RAPID UPDATE

Rapid Update 655 MC20 – AC pipe connection check

DATE: AUGUST 2 2023

4. Once the aerodynamic panel has been removed, locate the AC pipe connection to be checked, as indicated in the picture below.
 - **POS. 15 NUT - table 08.40 - 3 A/C UNIT: ENGINE COMPARTMENT DEVICES**

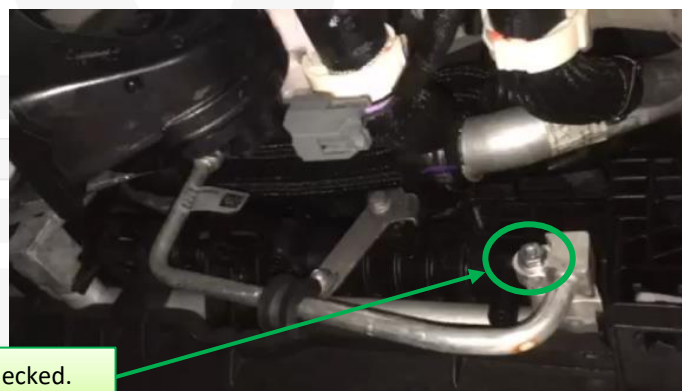
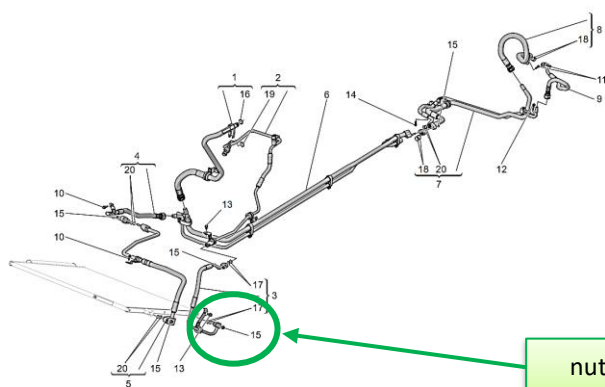
nut to be checked.

5. **Use a torque wrench:** Torque the nut to **9Nm (nine)**.

6. Screw connection	
7. Tightening nut	8. 9 Nm (6.6 ft-lb)

9. **ONLY IF the nut was not tightened to spec:** Check AC system operation. proceed with recharging the climate control system ONLY if needed. Per the workshop manual:
